**ISSUE:** Certificate of Appropriateness for new construction

**APPLICANT:** City of Alexandria and Washington Metropolitan Area Transit Authority (WMATA)

**LOCATION:** Old and Historic Alexandria District  
2500 Potomac Greens Drive (2405, 2501, 3701 Potomac Avenue, 3251 Potomac Avenue [Parcel ID 016.04-01-01], 700 Carpenter Road, 1702 and 1880 Potomac Greens Drive) 2901 Potomac Avenue (2405, 2501, 3701 Potomac Avenue, 3251 Potomac Avenue [Parcel ID 016.04-01-01], 700 Carpenter Road, 1702 and 1880 Potomac Greens Drive)

The BAR has been reviewing this enormous project through an iterative, cumulative process. The applicant has requested approval of the following three items at this hearing. The remaining items will be brought forward on December 18, or whenever they are ready. Item numbers below reference a spreadsheet that the applicant has used at the past several hearings and is included in the linked staff report of October 16, 2019.

4 DOWNSPOUT PLATFORM PLAN  
1 1/2" = 1'-0"

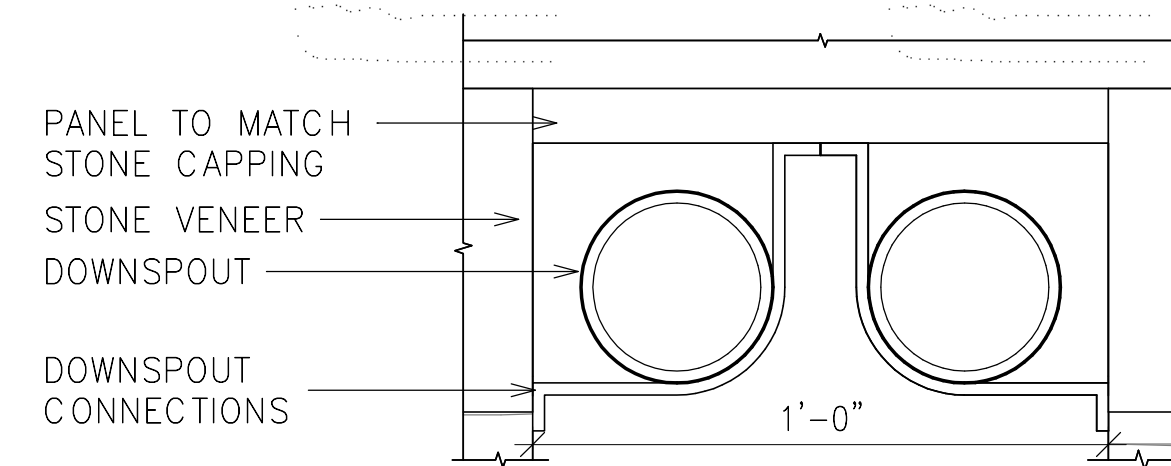
Having demonstrated that it was not possible to conceal the roof drainage system, the applicant has been working with staff to integrate the location of the downspouts into the overall architectural character of the station, as previously directed by the BAR. The downspout pipes have been grouped and aligned with truss extensions, the platform columns and the mezzanine exoskeleton framing. In some locations, this required pairing two downspouts to receive water draining in the gutter from two directions. While the final locations are now generally resolved, the architectural design of the downspouts themselves need additional refinement.

Staff recommends that there be a custom designed leader head at the drop from the gutter that combines both drains into a single rectangular downspout that can closely follow the truss extension and extend down to the rectangular reveal, or notch, in the fieldstone base. The stone base should have a metal cover plate that conceals the cleanout and the transition from the downspout into the underground stormwater system pipes. The design/build team concurs with this recommendation but did not have time to amend the illustrations for the December 4, 2019 hearing. Staff recommends approval of the general location of the downspouts with restudy of their shape and connection details.

1. Staff recommends approval of the downspout locations, the pedestrian bridge design details and of the architectural lighting of the station and pedestrian bridges but will closely follow the final light fixture details through the building permit process to ensure that they comply with the BAR's design intent to minimize glare toward the George Washington Memorial Parkway.
2. Staff recommends restudy of the shape and connection details of the downspouts.

WMATA POTOMAC YARD METRORAIL STATION				
ARCHITECTURAL				
PEDESTRIAN BRIDGE AND RAMP				
HANDRAIL DETAILS - DESIGN OPTION				
M NO.	CONTRACT NO.	SCALE:	DRAWING NO.	SHEET NO.
M1316	FQ16146		13-A-509

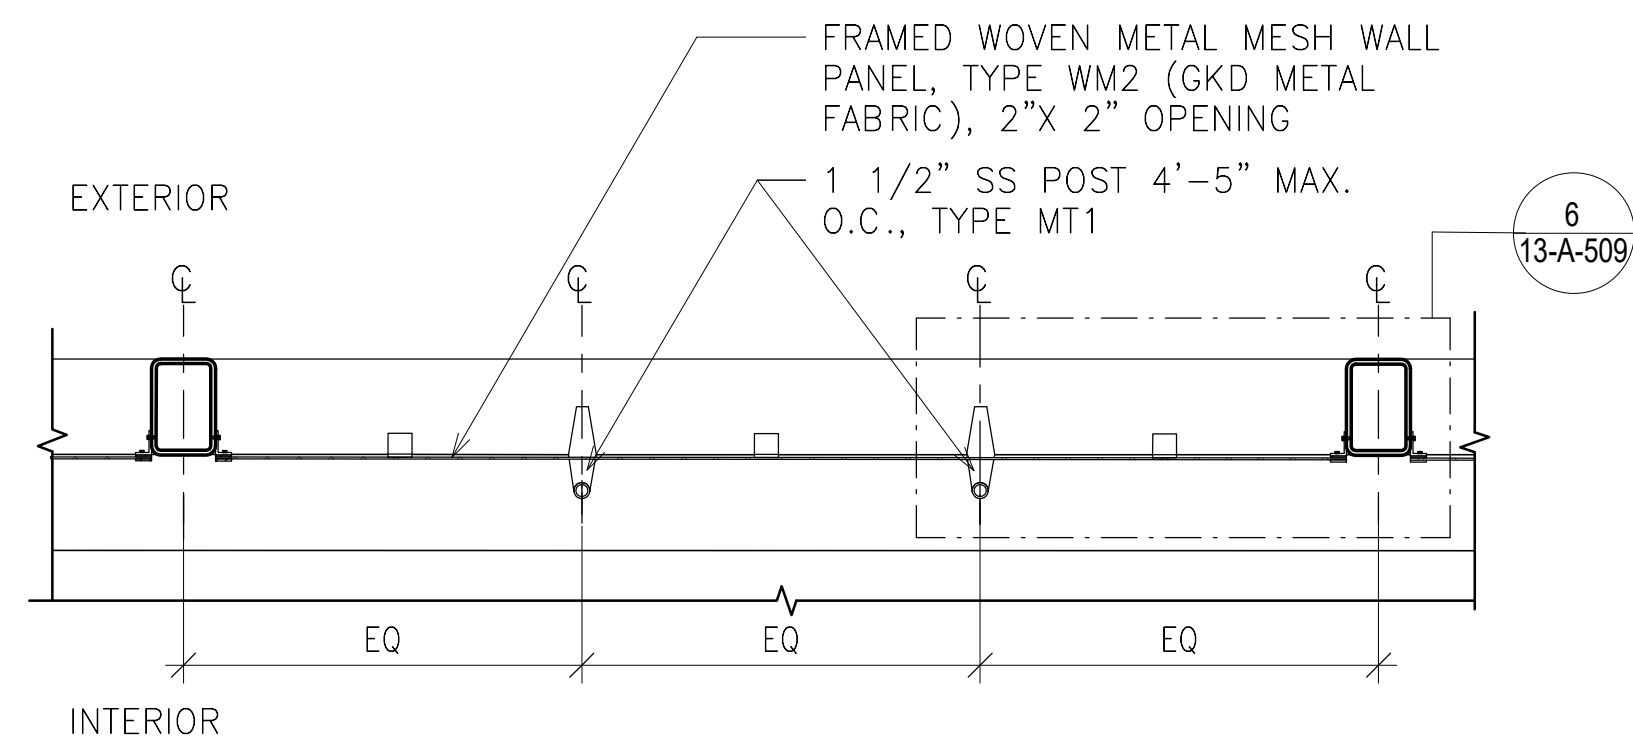
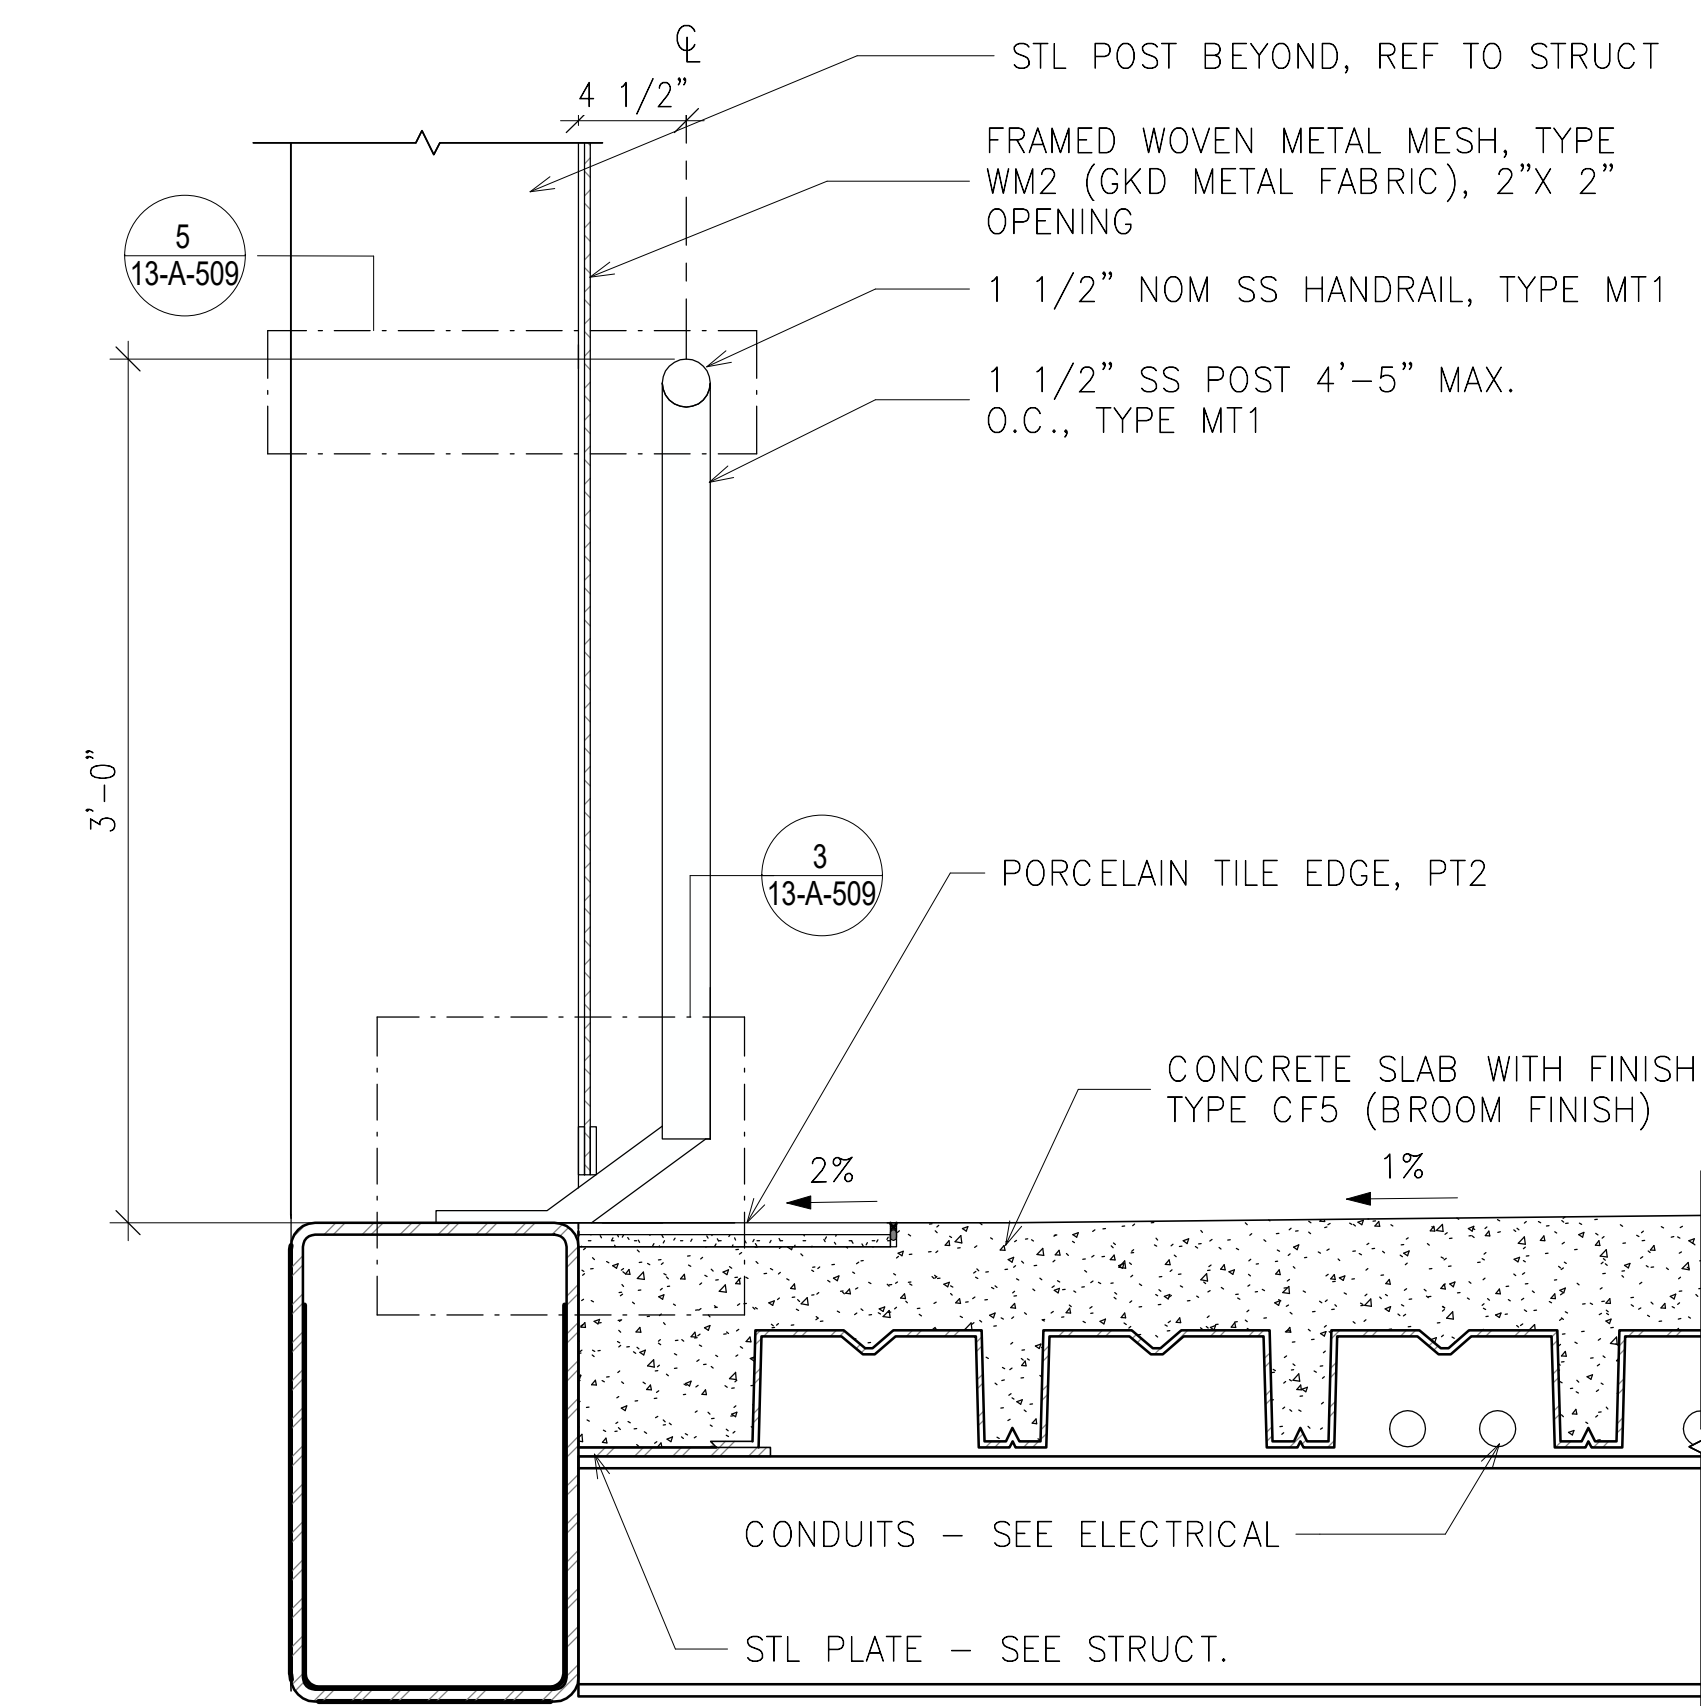
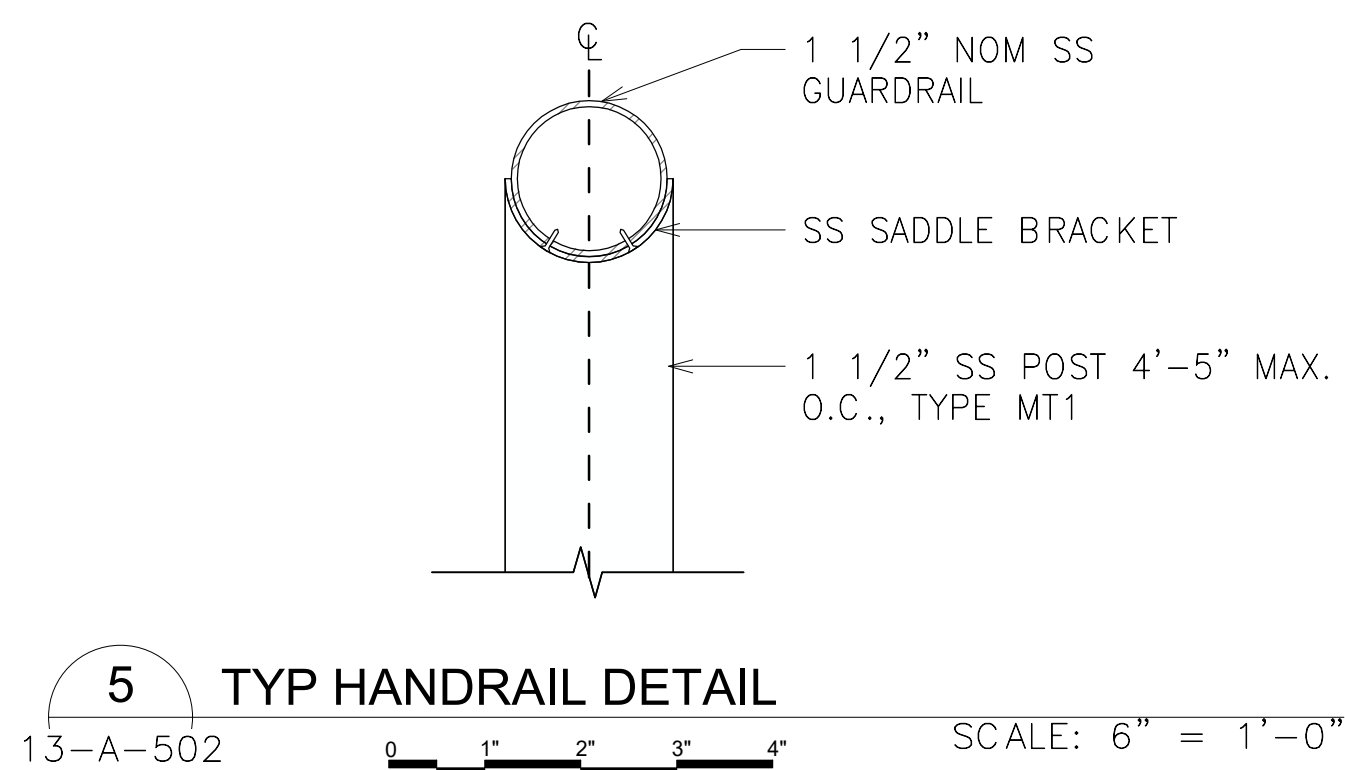
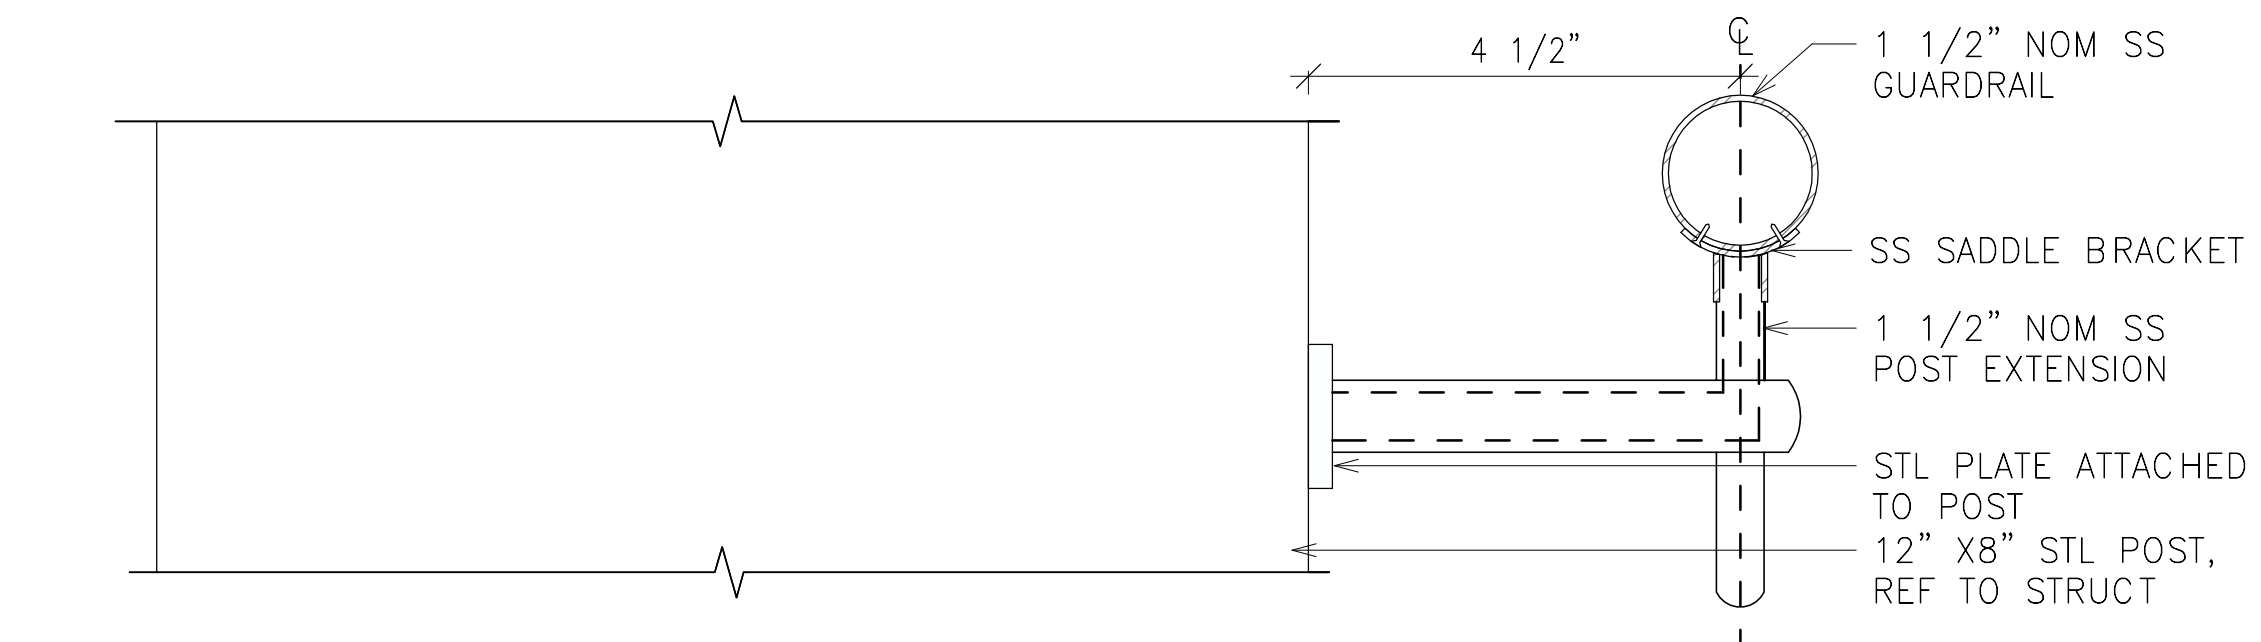
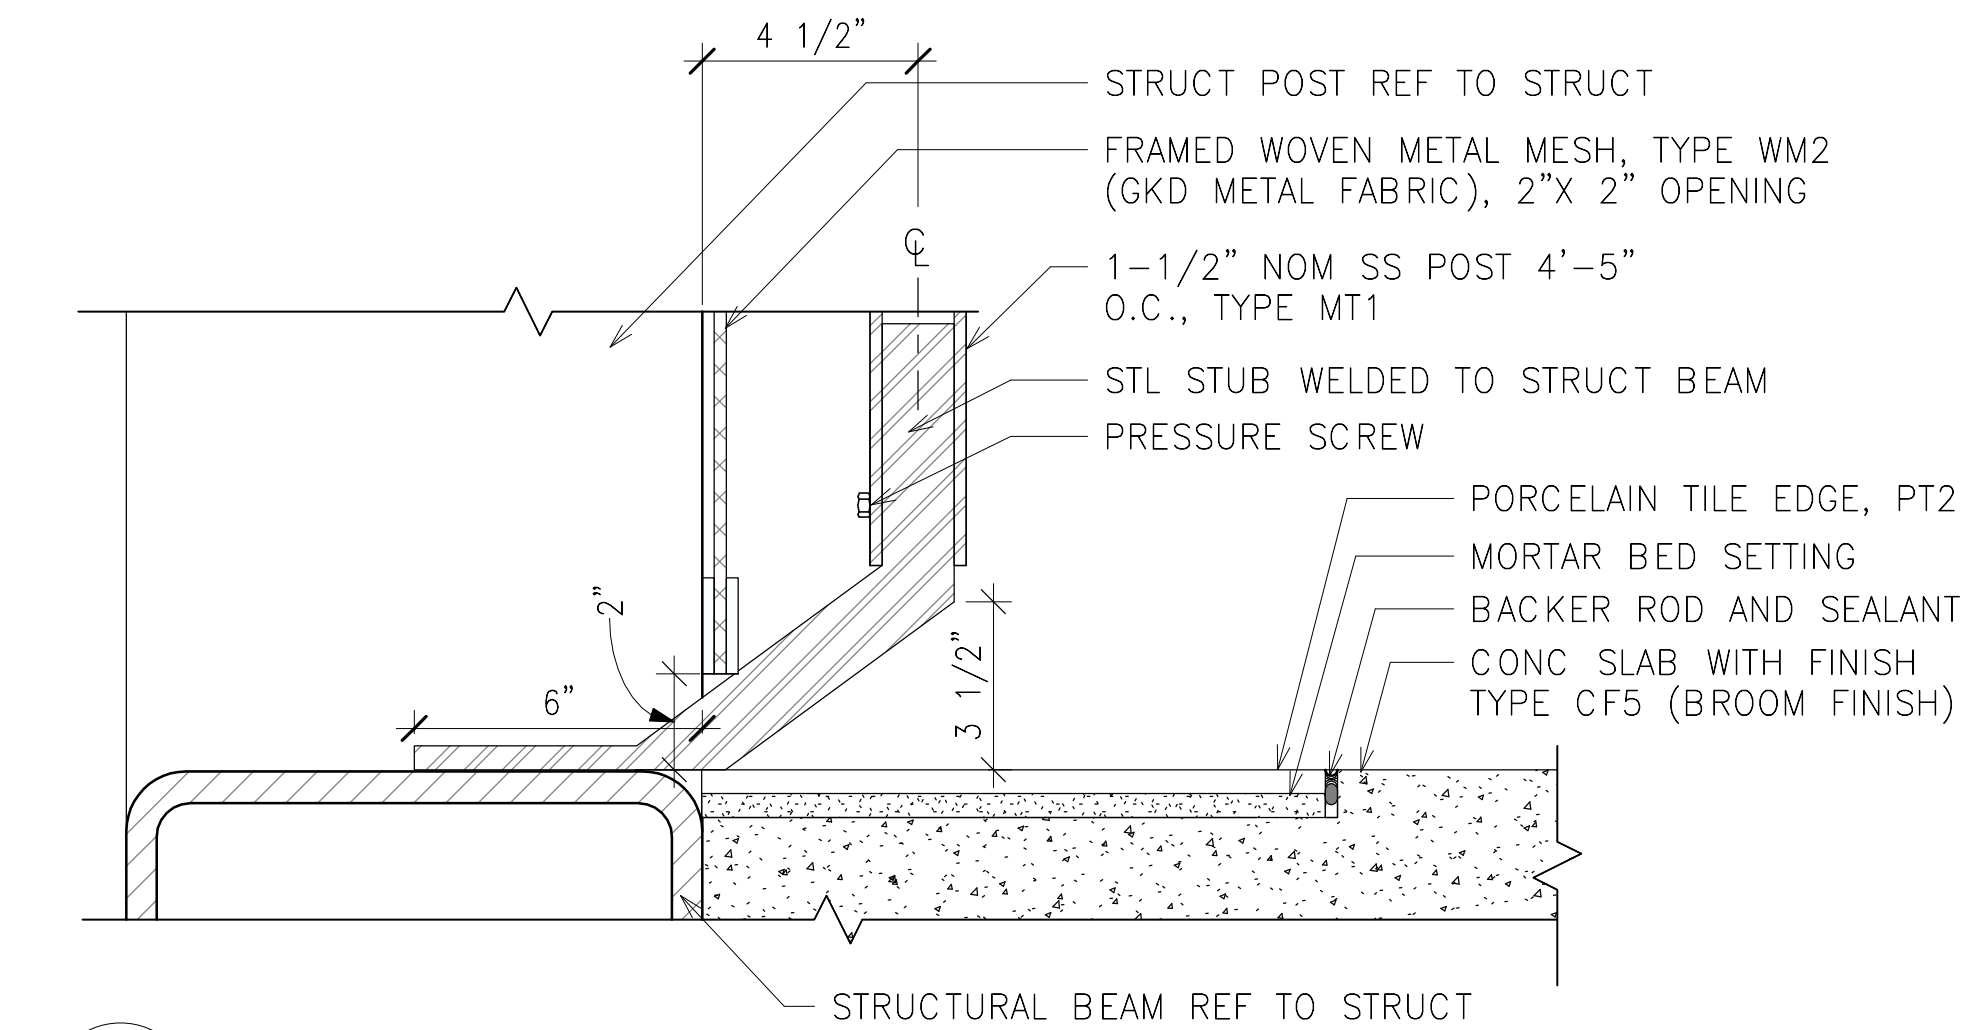
At the previous hearing, the BAR approved simplified, curved rafters for the pedestrian bridges and the installation of the woven metal mesh “fence” on the inside of the truss, with a request to restudy the number of handrails required by code and how they will attach to the floor and/or truss – the design goal of the BAR being to visually simplify the construction details, similar to other recent WMATA stations. The design/build team has submitted engineering calculations to the City and WMATA to confirm that the 2” x 2” stainless steel woven metal mesh held by a perimeter frame secured to the truss will itself meet the code requirements for a guard rail, so that one of the two previously shown horizontal handrails may be eliminated. The handrail stanchions at the vertical truss chord locations have also been eliminated and a simple bracket, shown in detail 4/13-A-502, is being used at all vertical chords and on handrail supports inside the station. This eliminates one-third of the vertical stanchions in the walkway. In addition, the base of the stanchions supporting the handrail have been angled so that they may be welded to the bottom chord of the truss for constructability and maintenance reasons. This is similar to the stanchion base used at the Silver Line Metro station that the BAR saw at a previous hearing. Staff recommends approval of the revised handrail design.
